SUNDRY NOTICES AND REPORTS ON WELLS

7. If Unit or CA/Agreement, Name and/or No.
891000303X8. Well Name and No.
POKER LAKE UNIT 29 BS 121H9. API Well No.
30-015-45935-00-X110. Field and Pool or Exploratory Area
POKER LAKE-DELAWARE, SW11. County or Parish, State
EDDY COUNTY, NM

XTO Permian Operation, LLC requests permission to make the following changes to the original APD:

13-3/8" x 9-5/8" x 7" 15M RSH-2 Wellhead
Assembly, With T-EBS-F-HP Tubing Head

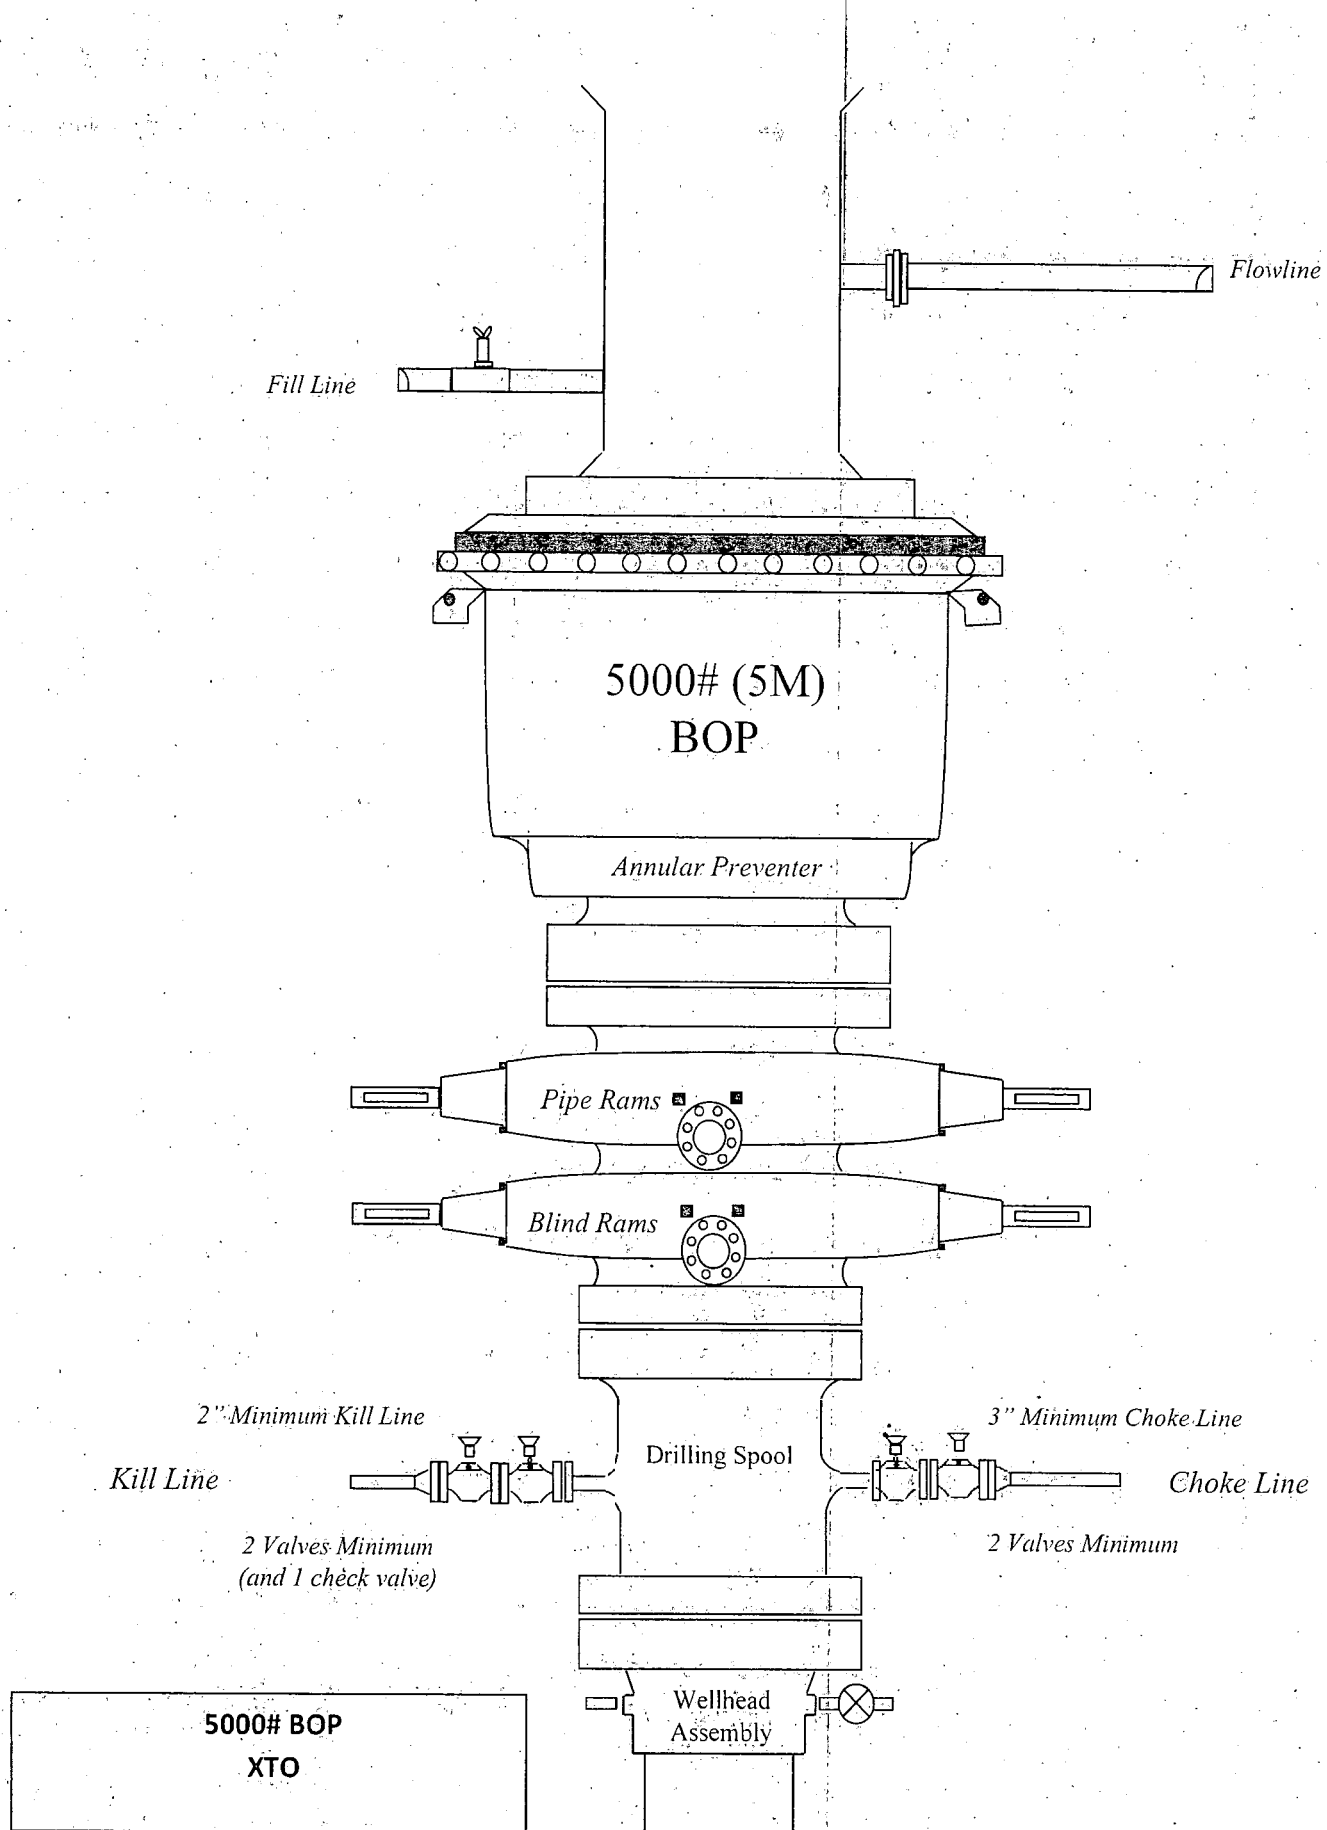
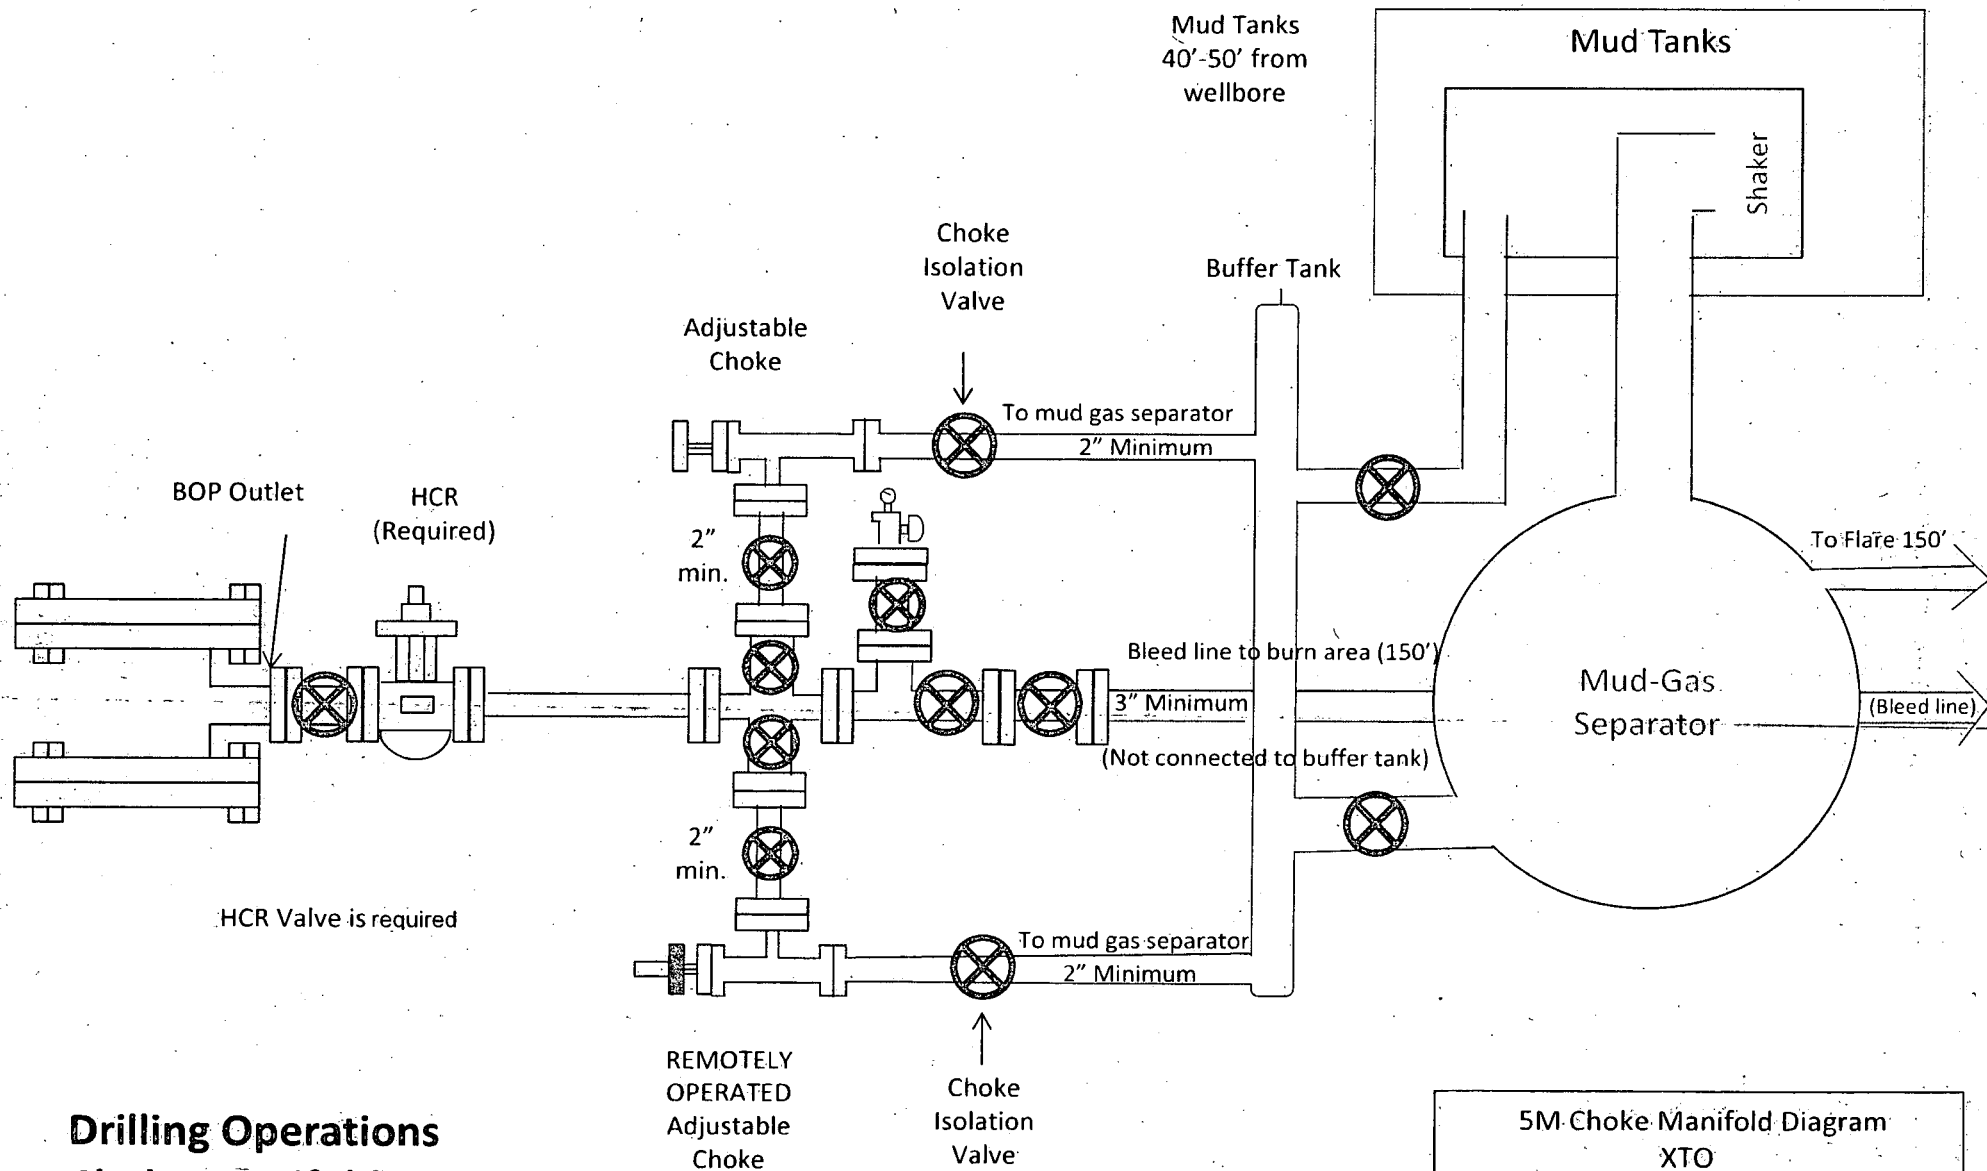
- Wellhead will be installed by manufacturer's representatives.
- Manufacturer will monitor welding process to ensure appropriate temperature of seal.
- Operator will test the 7-0" casing per BLM Onshore Order 2
- Wellhead Manufacturer representative will not be present for BOP test plug installation

3. Operator has proposed a multi-bowl wellhead assembly. This assembly will only be tested when installed on the surface casing. Minimum working pressure of the blowout preventer (BOP) and related equipment (BOPE) required for drilling below the surface casing shoe shall be 5000 (5M) psi.

- a. Wellhead shall be installed by manufacturer's representatives, submit documentation with subsequent sundry.
 - b. If the welding is performed by a third party, the manufacturer's representative shall monitor the temperature to verify that it does not exceed the maximum temperature of the seal.

- c. Manufacturer representative shall install the test plug for the initial BOP test.
 - d. Operator shall perform the 9-5/8" and 7" casing integrity tests to 70% of the casing burst. This will test the multi-bowl seals.

5M Choke Manifold Diagram
XTO

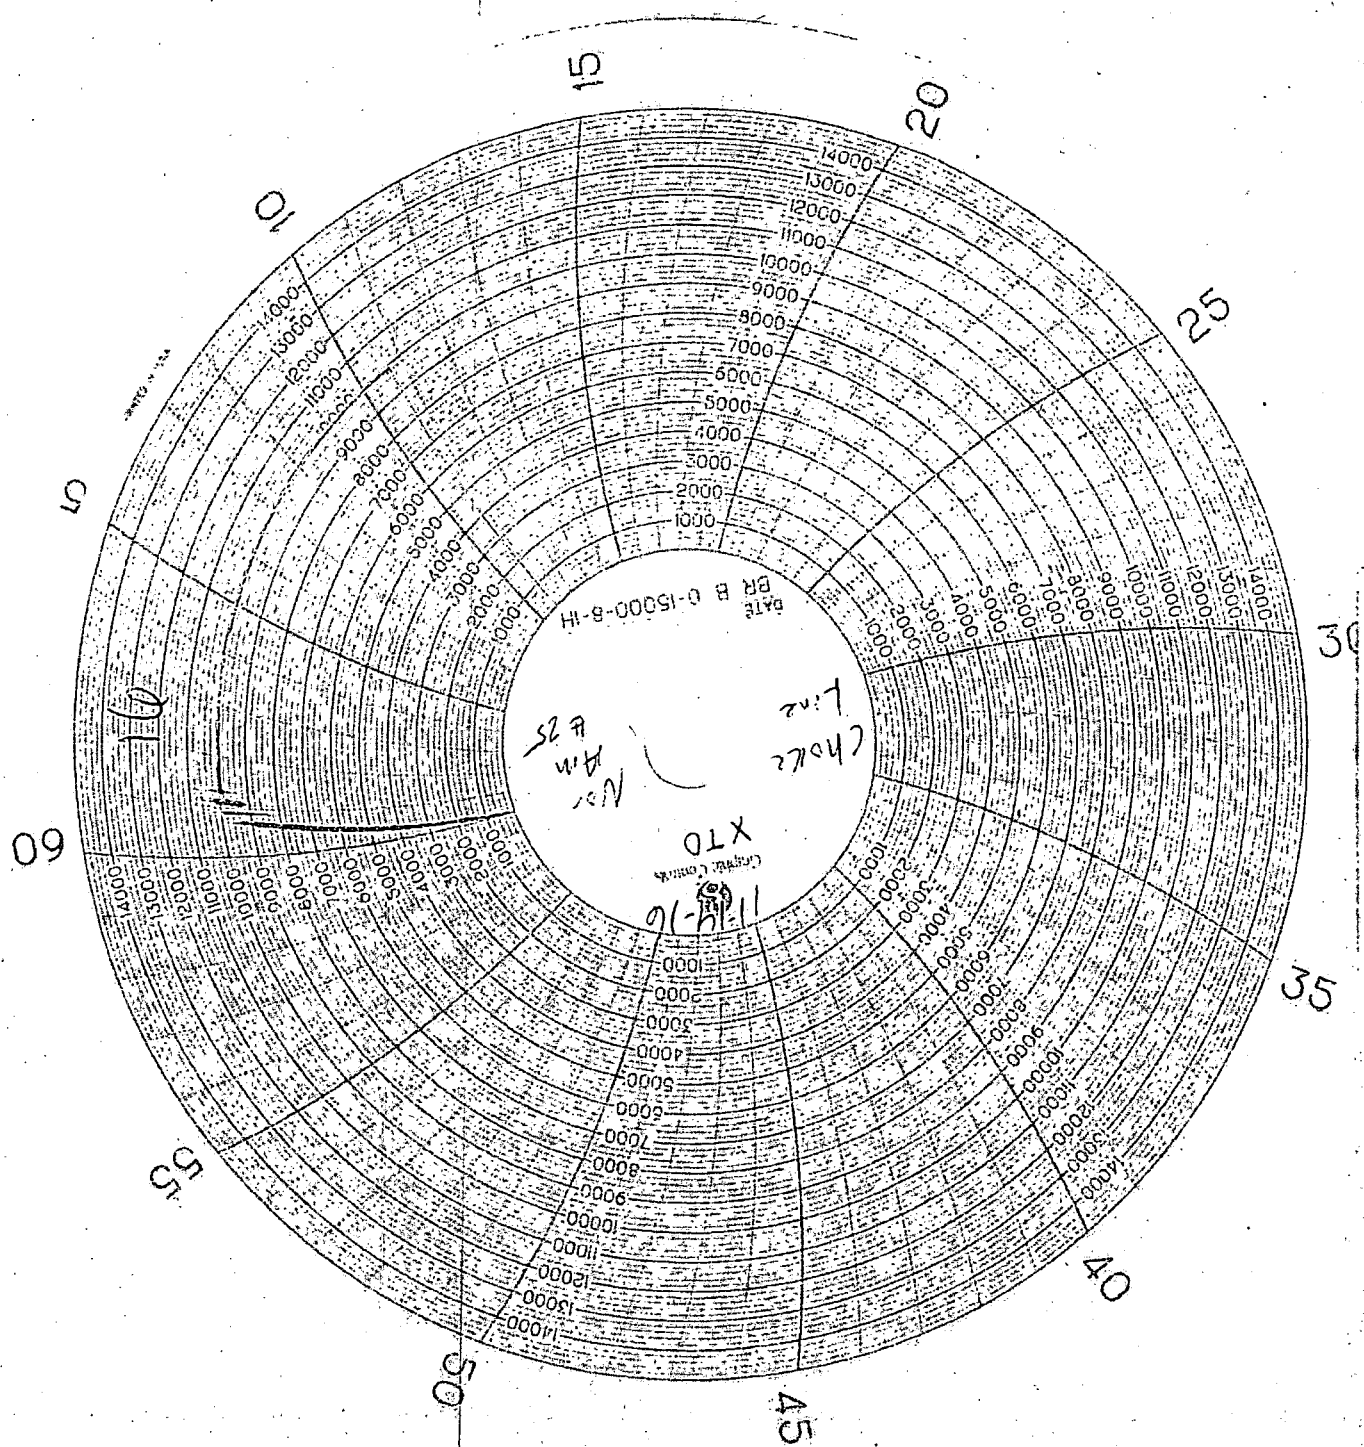
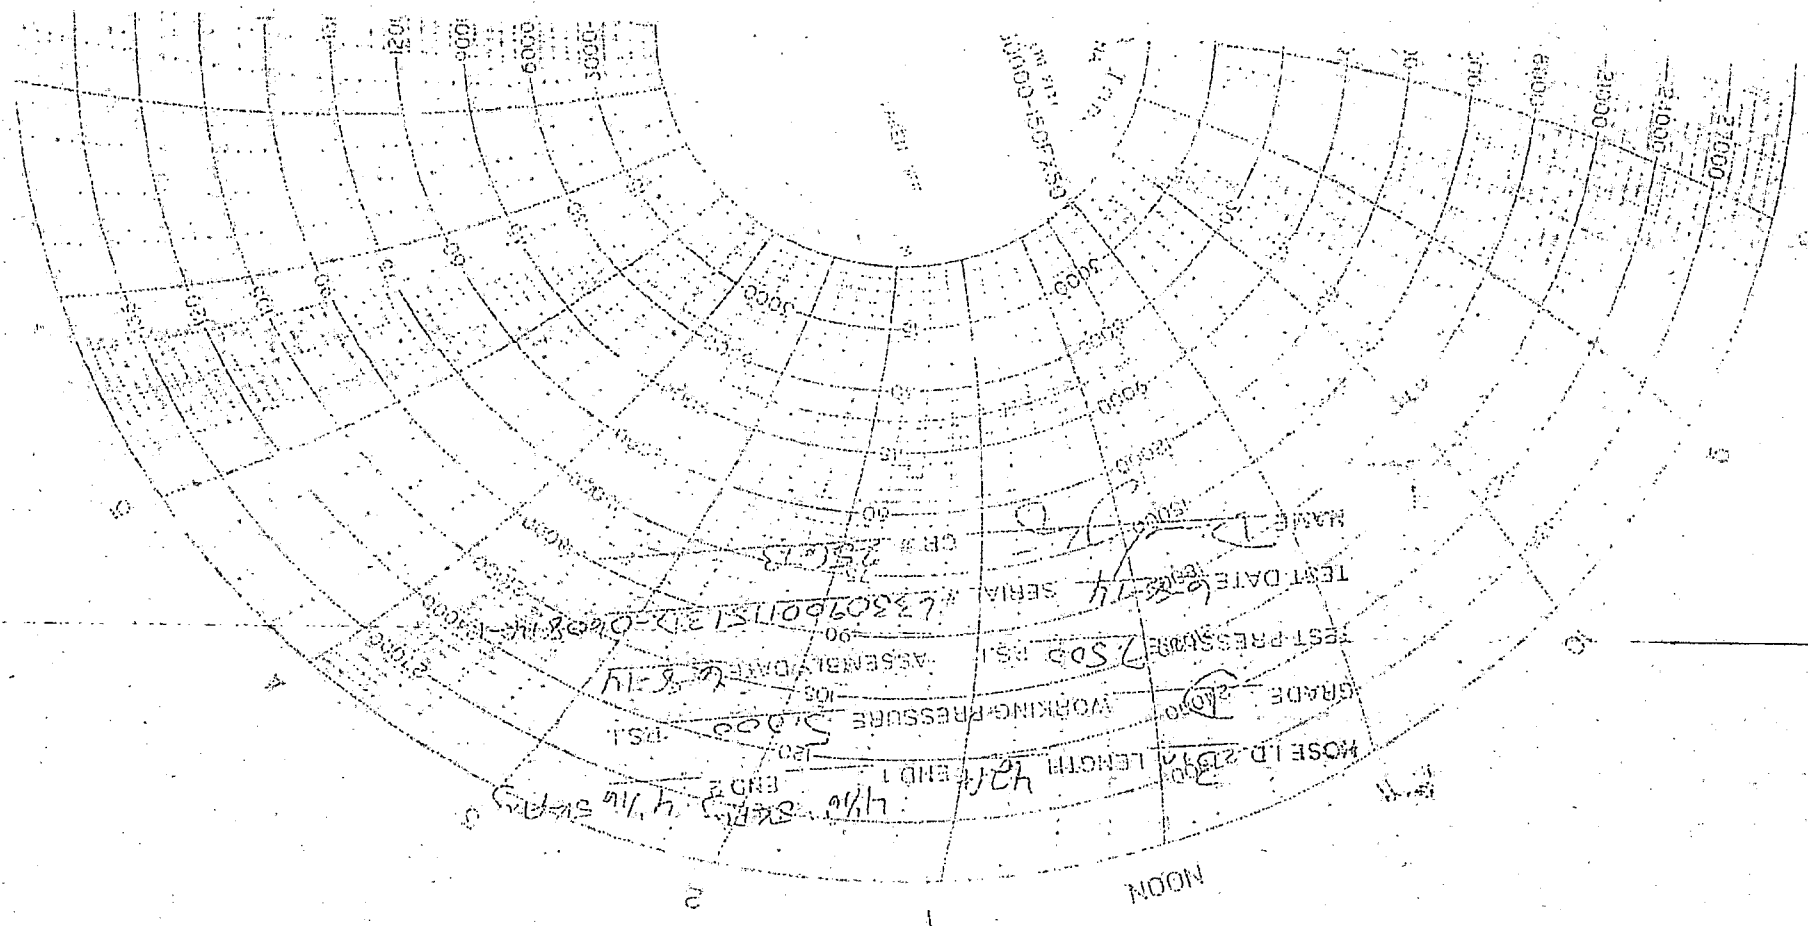
A variance is requested to allow use of a flex hose as the choke line from the BOP to the Choke Manifold. If this hose is used, a copy of the manufacturer's certification and pressure test chart will be kept on the rig. Attached is an example of a certification and pressure test chart. The manufacturer does not require anchors.

2. Variance approved to use flex line from BOP to choke manifold. Check condition of flexible line from BOP to choke manifold, replace if exterior is damaged or if line fails test. Line to be as straight as possible with no hard bends and is to be anchored according to Manufacturer's requirements. The flexible hose can be exchanged with a hose of equal size and equal or greater pressure rating. **Anchor requirements, specification sheet and hydrostatic pressure test certification matching the hose in service, to be onsite for review. These documents shall be posted in the company man's trailer and on the rig floor.** If the BLM inspector questions the straightness of the hose, a BLM engineer will be contacted and will review in the field or via picture supplied by inspector to determine if changes are required (operator shall expect delays if this occurs).
